OIL CONSERVATION DIVISION
1220 South St. Francis Dr.
Santa Fe, NM 87505

Graham AKB State

SUNDRY NOTICES AND REPORTS ON WELLS
(DO NOT USE THIS FORM FOR PROPOSALS TO DRILL OR TO DEEPEN OR PLUG BACK TO A DIFFERENT RESERVOIR. USE "APPLICATION FOR PERMIT" (FORM C-101) FOR SUCH PROPOSALS.)

Yates Petroleum Corporation plans to plug and abandon this well as follows:

WELL NAME: Graham "AKB" State No. 3FIELD: Lost TankLOCATION: Unit B, 660' FNL & 1,650' FEL Sec 2-23S-31E

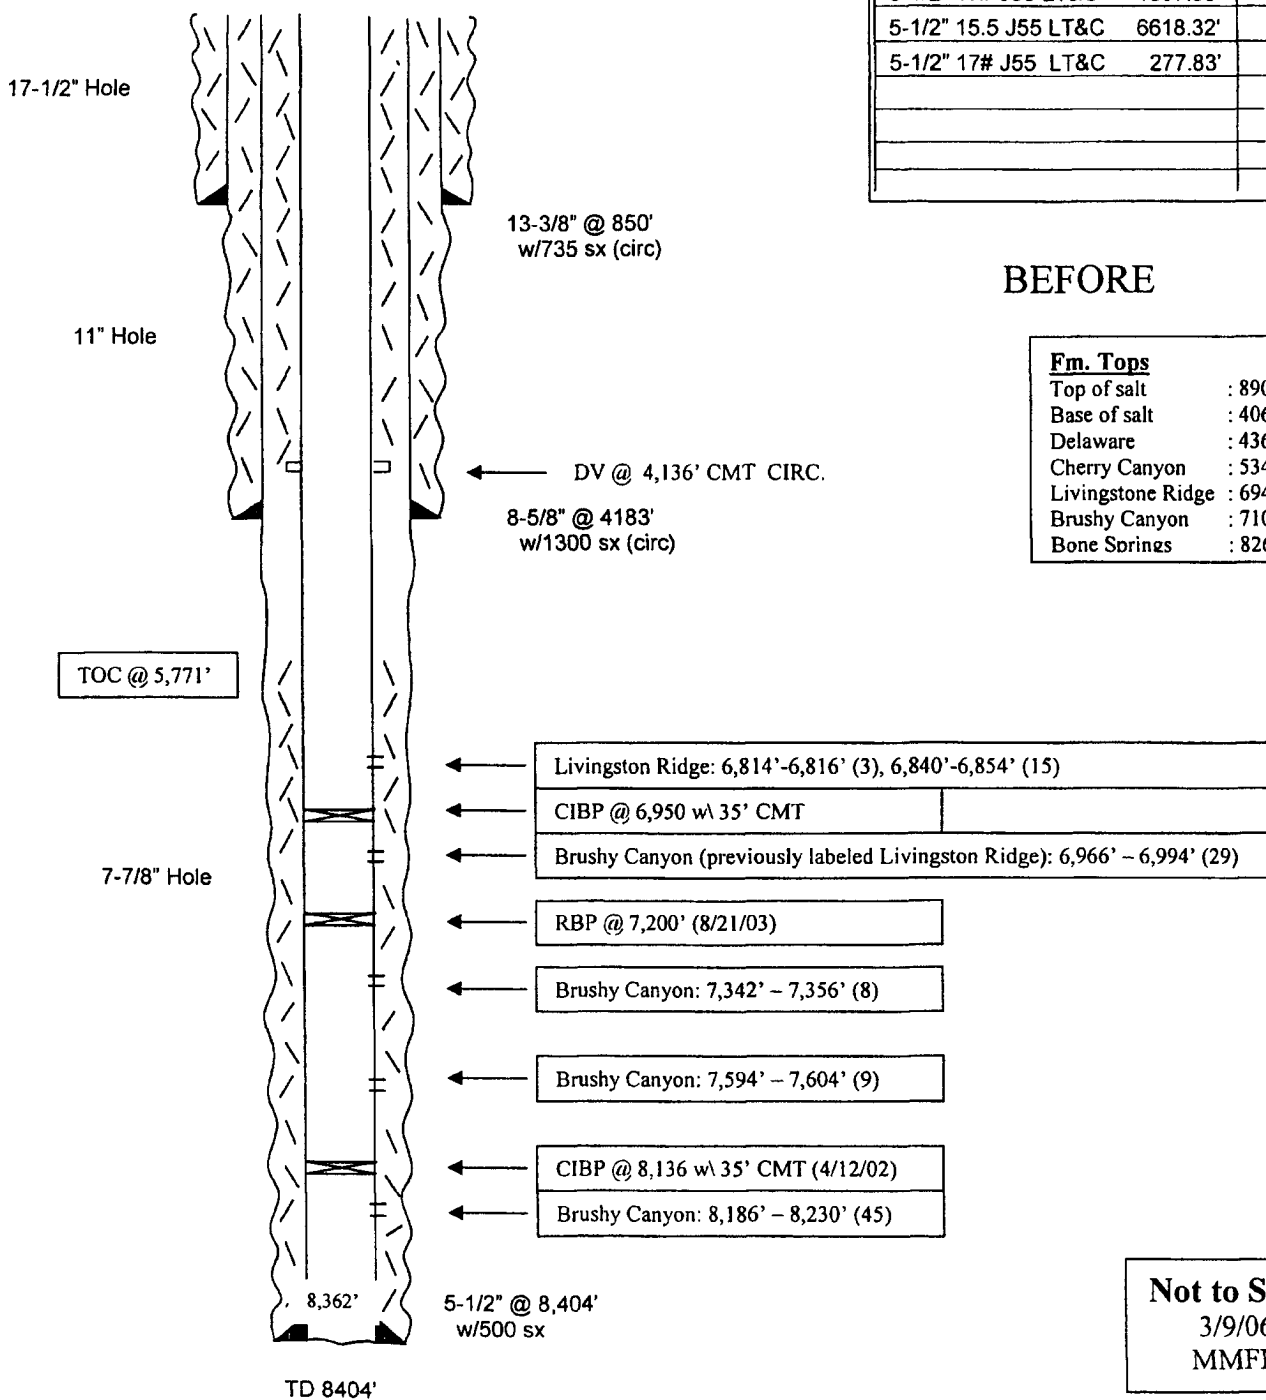
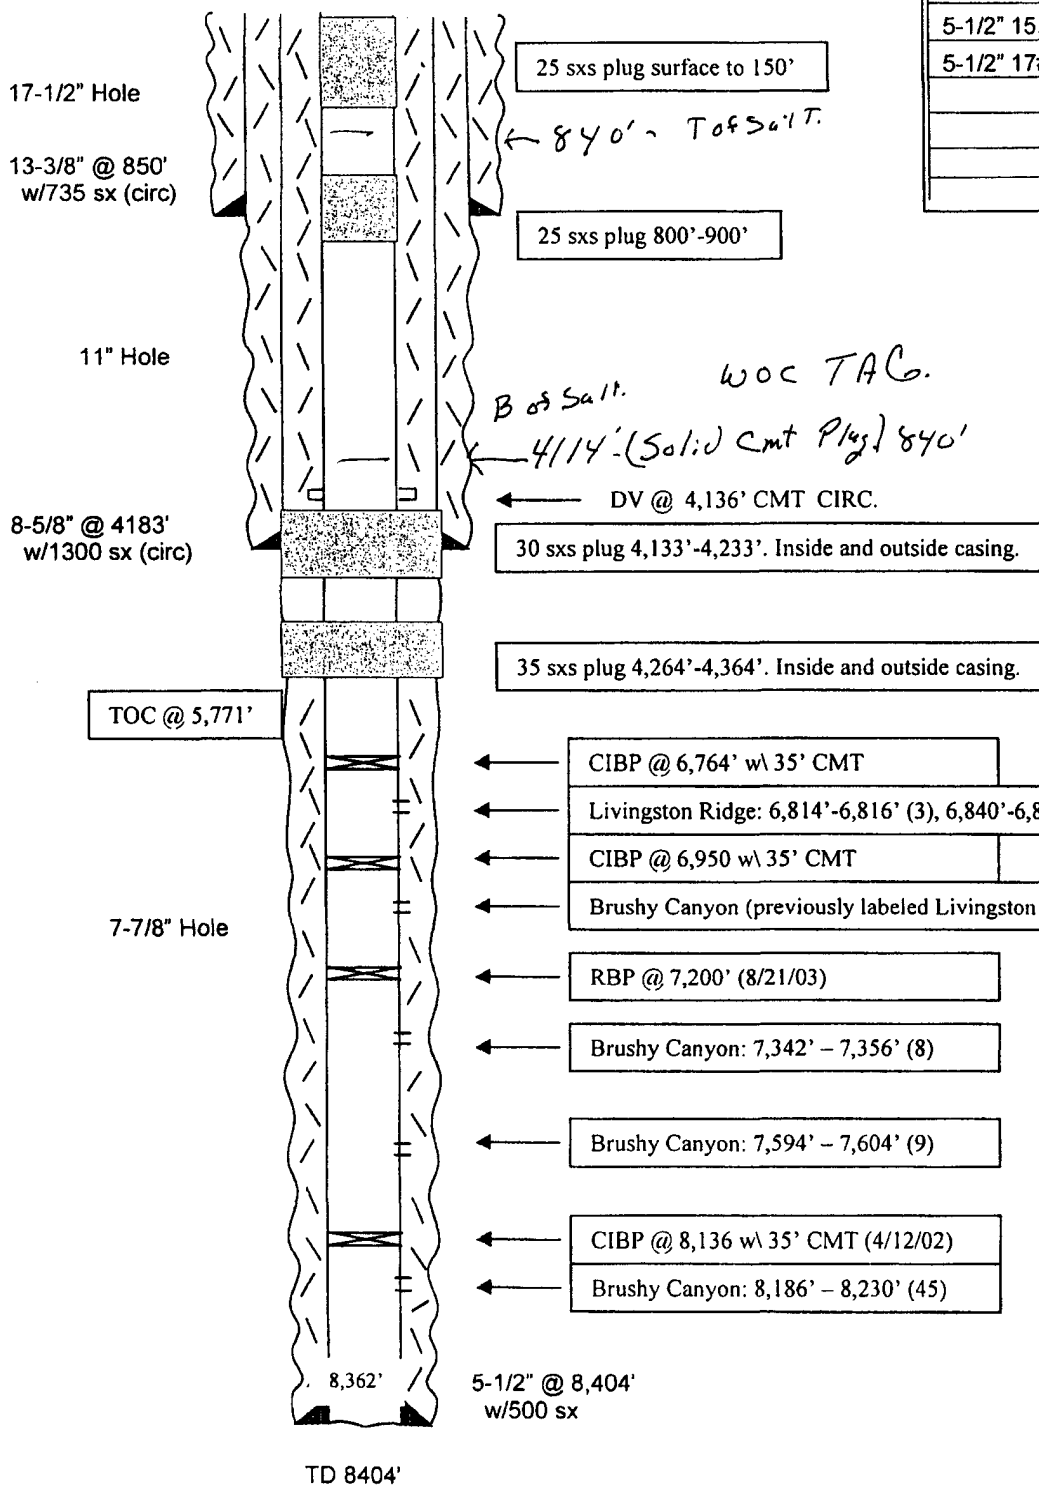
1. MIRU safety equipment as needed. No casing recovery will be attempted.
2. Set a CIBP at 6764' with 35' cement on top. This puts a plug over the open perforations.
3. Perforate 5-1/2" casing at 4364' and spot a 35 sx Class "C" cement plug from 4264'-4364'. This puts a 100' plug across the Delaware top, inside and outside casing. WOC and tag plug.
4. Perforate at 4233' and spot a 30 sx Class "C" cement plug from 4133'-4233', across the intermediate casing shoe, inside and outside the casing. WOC and tag plug.
5. Spot a 25 sx Class "C" cement plug from 800'-900', across the surface casing shoe, inside and outside the casing. WOC and tag plug.
6. Spot a 25 sx Class "C" cement plug from 150' up to the surface.
7. Remove all surface equipment, weld dry hole marker and clean location as per regulations.

* CMT Plug @ 4114' - 840' WOC TAG

(X) Revised 12/22/06 Phil Hankin
